AGENDA

La Vergne Planning Commission
July 29, 2025 at 6:00 PM

Item #: 3. Site Plan – Smoke Club 13 – New Building of 2,759 Square Feet on 0.42 Acres. Requested by Dean Design Group. Property located at 5234 Murfreesboro Road (Tax Map 15M, Group C, Parcel 6). C-2 (Highway Service) Zoning District. Property owned by Smoke Club 13, LLC. (DEFERRED)

C3.1
GRADING PLAN

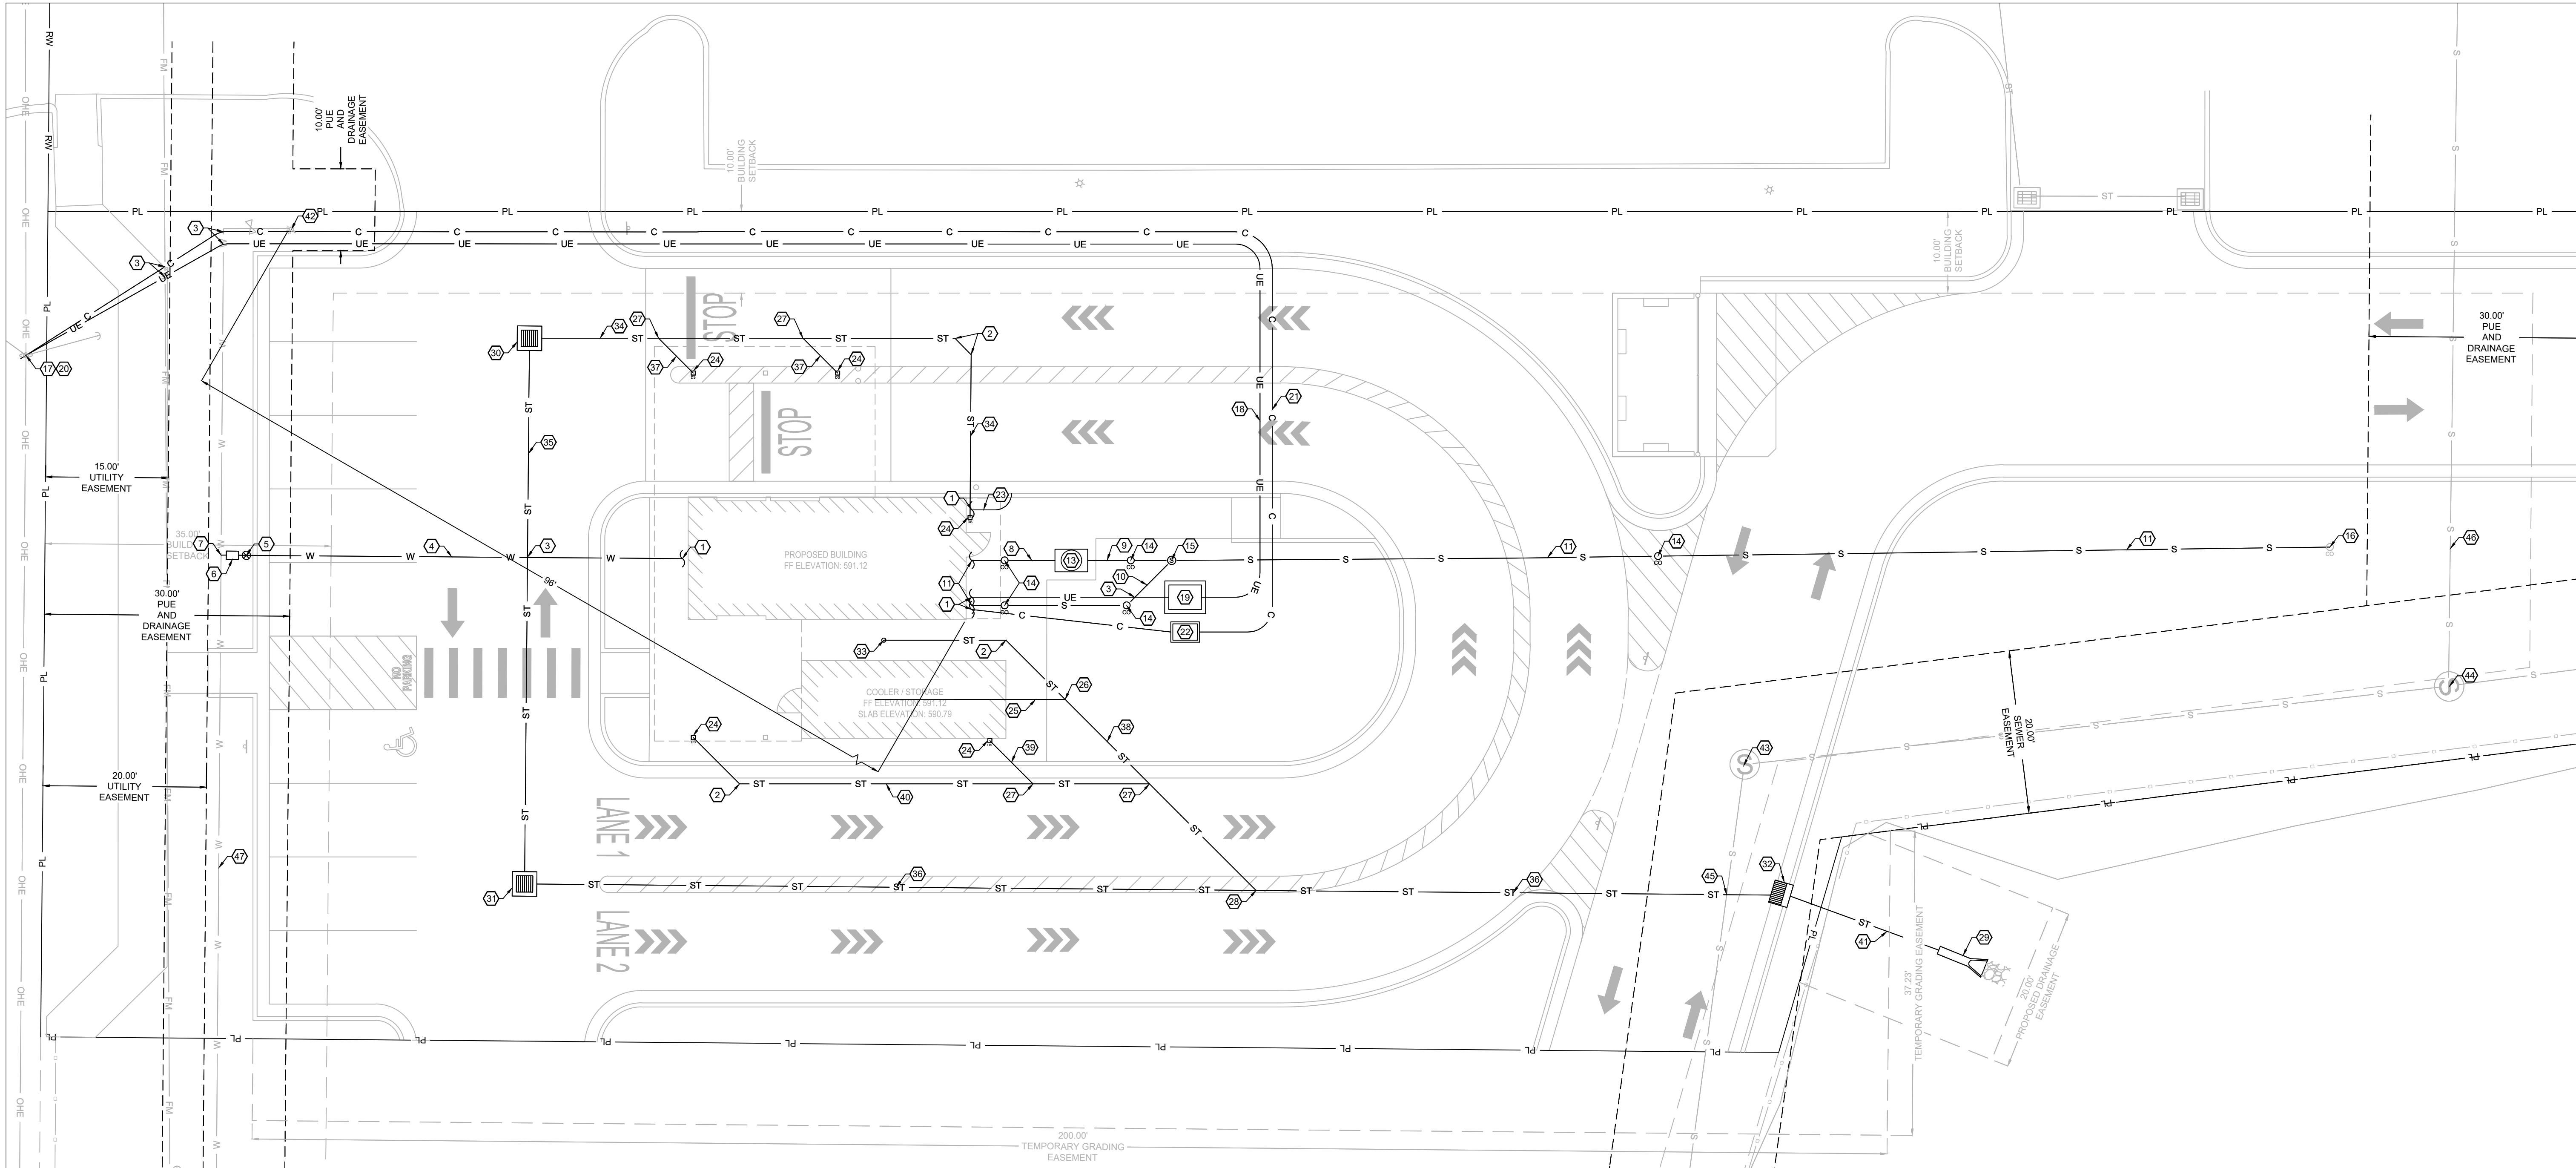
1. (Sheet C3.1 and C4.1) Regarding offsite grading and drainage. The engineer's response to the comment regarding offsite easements is as follows: "The coordination of an easement has started, and a proposed drainage easement to the north has been added to the plans." No documentation has been provided indicating that negotiations with the affected landowner (Villas at Central Park) have been successfully concluded. If those negotiations do not end up with an easement, then the grading and drainage plans as shown will not work.

C4.1
UTILITY PLAN

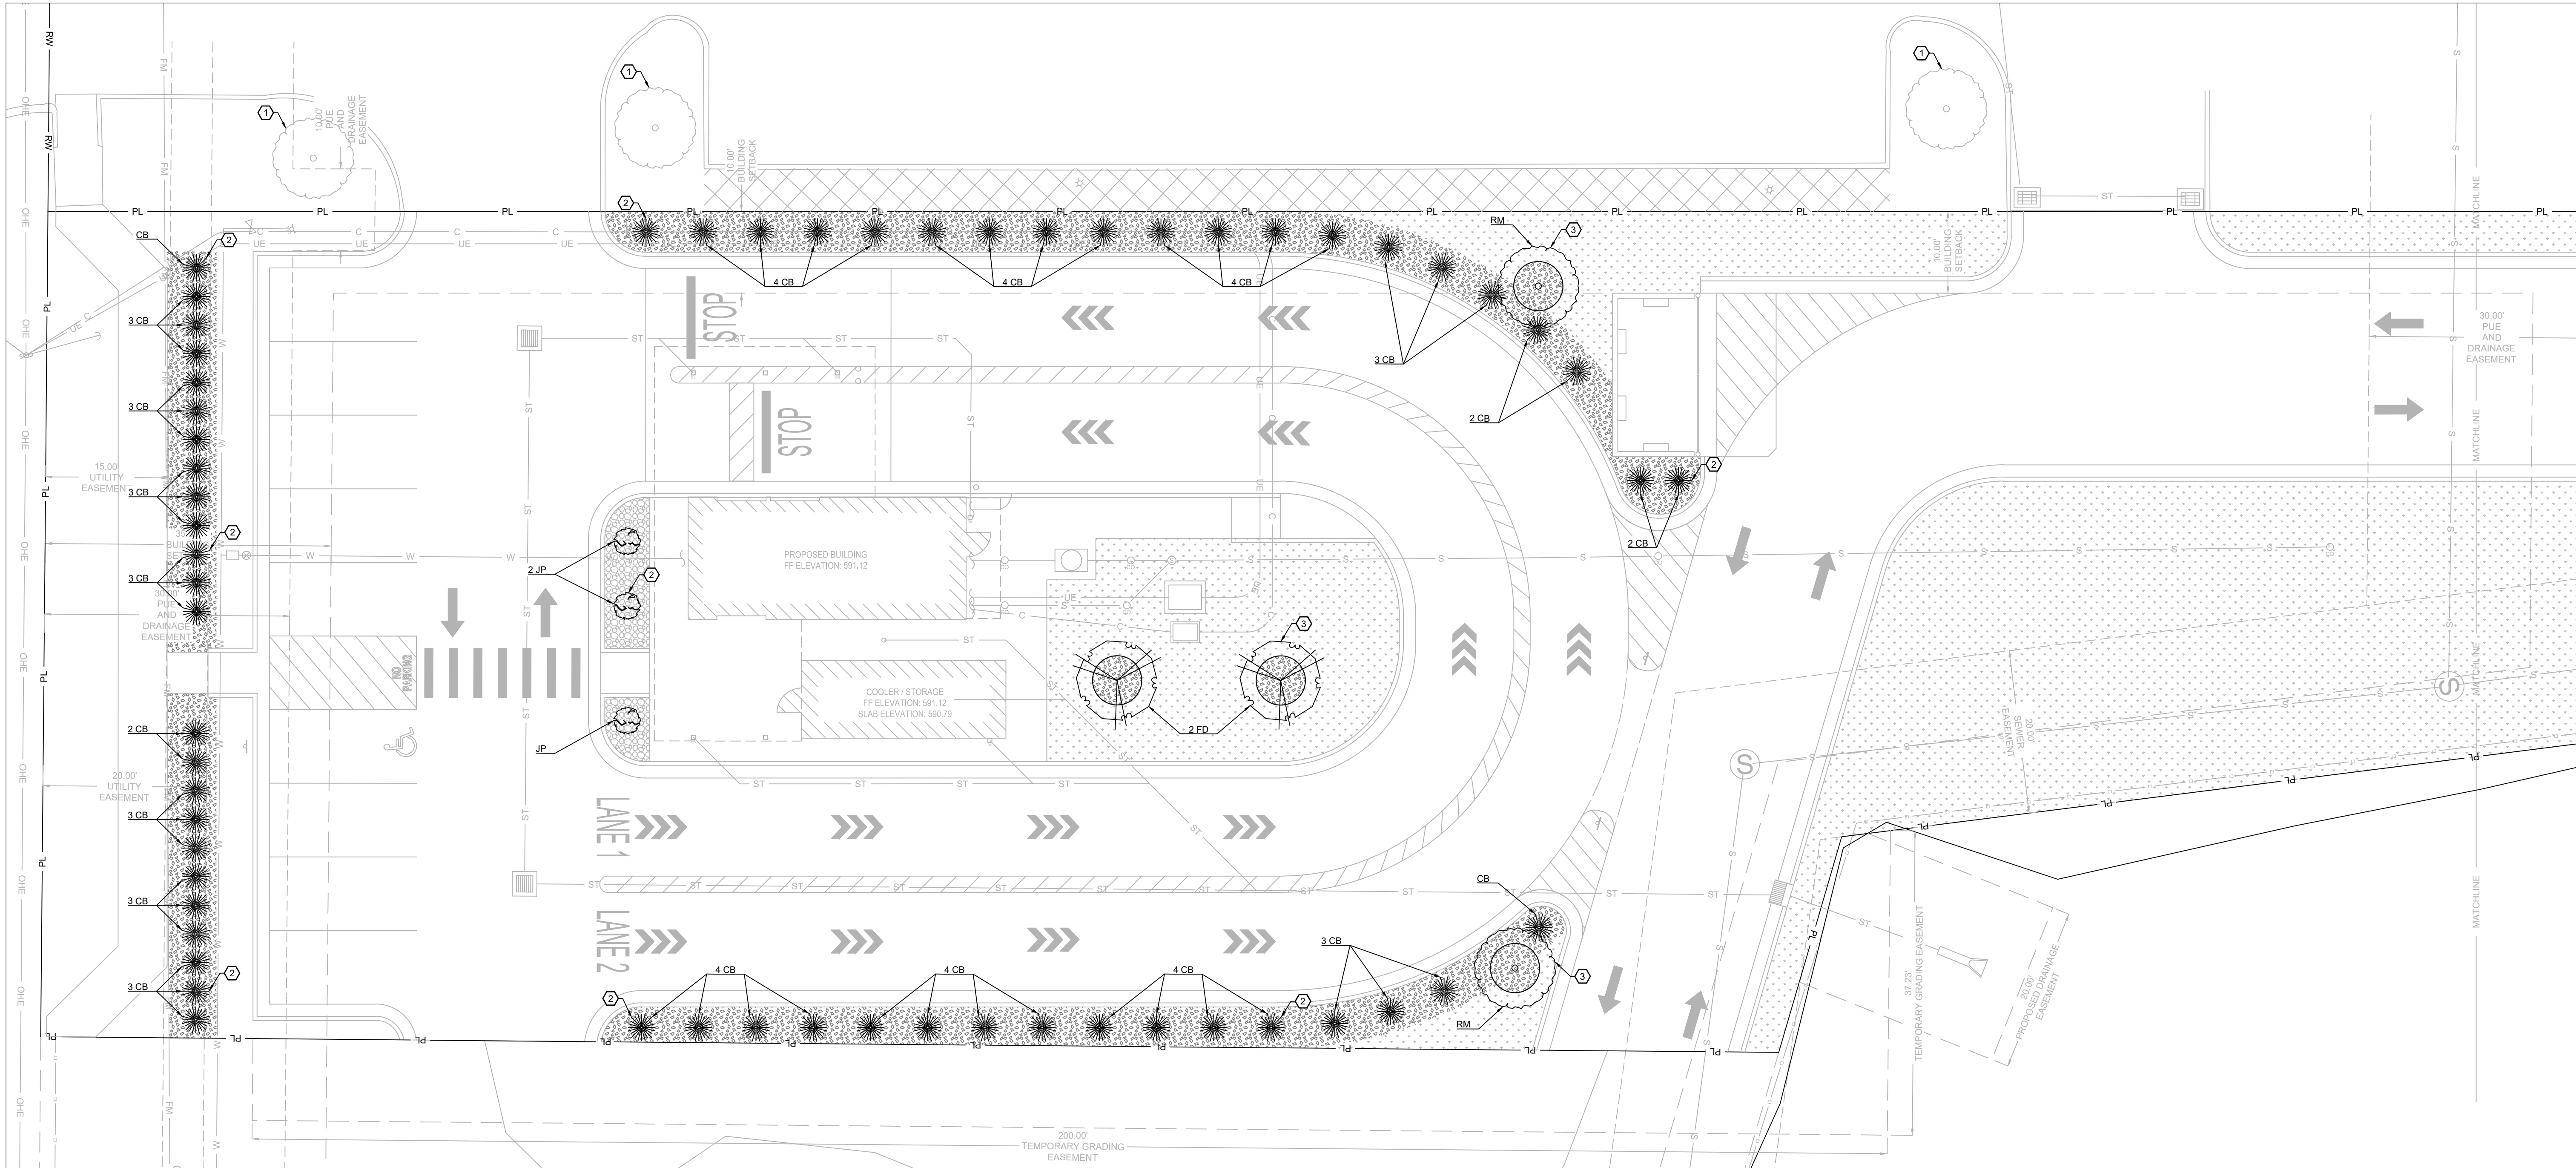
2. (Sheet C4.1) Calculations provided do not account for head losses from bends, junctions, and wyes.
3. (Sheet C4.1) Calculations provided do not show the amount of surface flow (25-year/24-hour) from the main queuing lanes planned to cross the drive in the north portion of the site before entering curb inlet #32.

4. (Sheet C4.1) Calculations provided do not demonstrate that curb inlet #32 can handle the 25-year/24-hour run-off from the entire site assuming that the underground system is clogged.

6. Sht C4.1 - Show and label "Existing 12" H.P. Gas Transmission Main, Piedmont/Duke Energy" within the ROW of Murfreesboro Rd where it exists (just south of the OHE line alignment).

7. Sht C4.1 – Show and label "Existing 6" Gas Distribution Line, Town of Smyrna" within the ROW of Murfreesboro Rd where it exists (just south of the 12" H.P. Gas line).

8. Sht C4.1 - Place a note on the utility plan to "Contact Josh Robinson, Operations Utility Technician, Piedmont/Duke Energy, C: 615-476-9885, Joshua.Robinson@duke-energy.com prior to excavation over the 12" high pressure gas transmission line. Piedmont shall witness excavation over their line."

9. Sht C4.1 – Show and label existing public sewer service line from existing public cleanout to existing 8" public gravity sewer. Label existing sewer service line as "Existing 6-inch Public Sewer Service." Everything beyond this existing service line is a private sewer plumbing line by property owner.
